AS BUILT

NEW BOUNDARY WALLS & AMENDMENTS TO APPROVED PLAN NO. 0486/10/90/1 FOR MR H FRANZ AT 27 MUSGRAVE AVE, BEREA SUB K OF 2 & 3 OF LOT B

Drawing No 91/3363

FLOOR PLAN 1:100

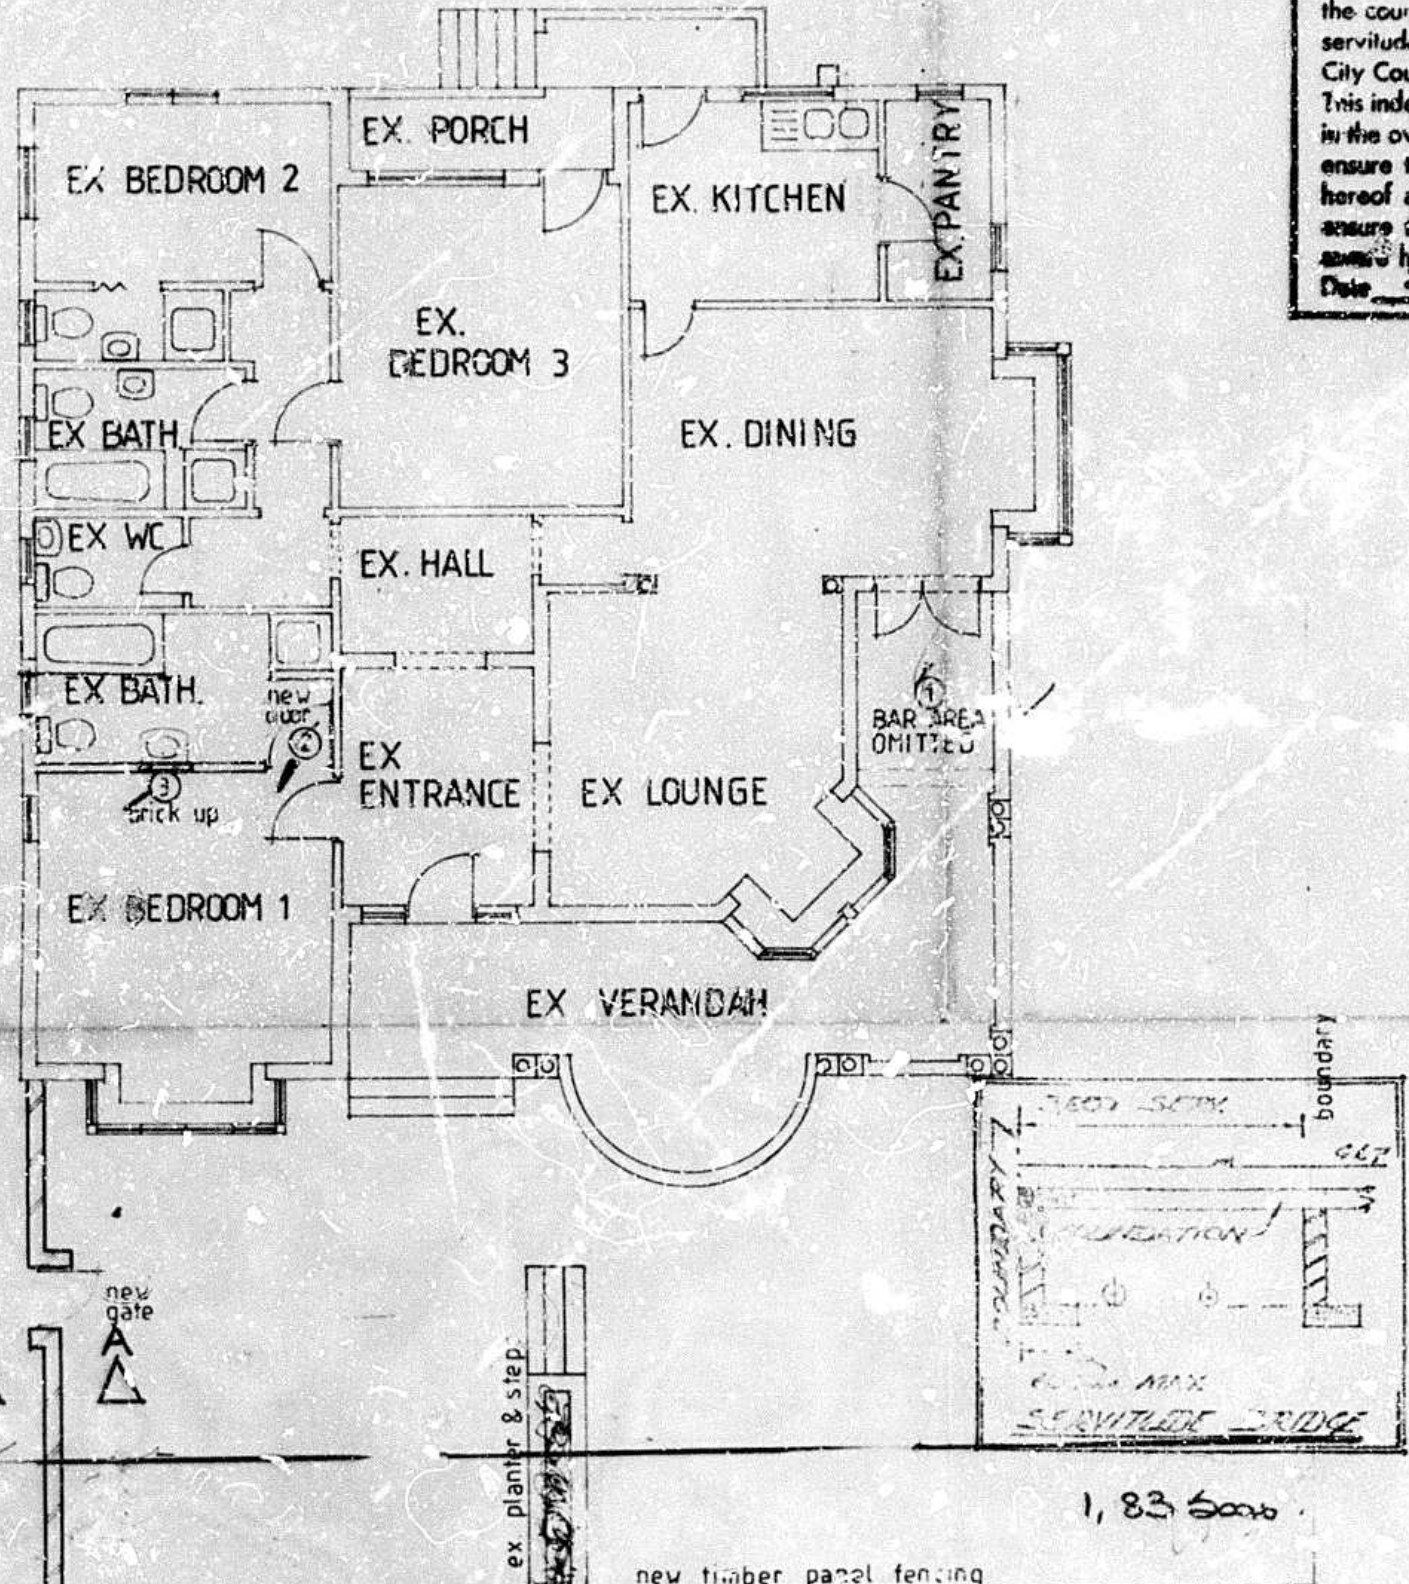
AMENDMENTS

- 1 OMIT LAR AREA
- 2 NEW DOOR
- 3 BRICK UP DOOR

BRIDGING DETAIL

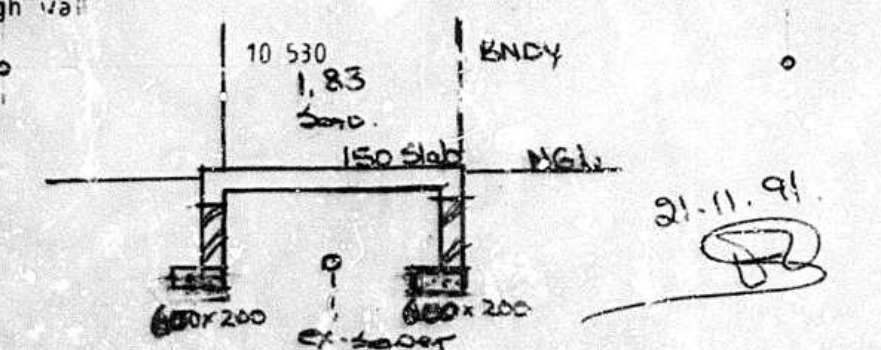
New walls to be bridged over D.C. services
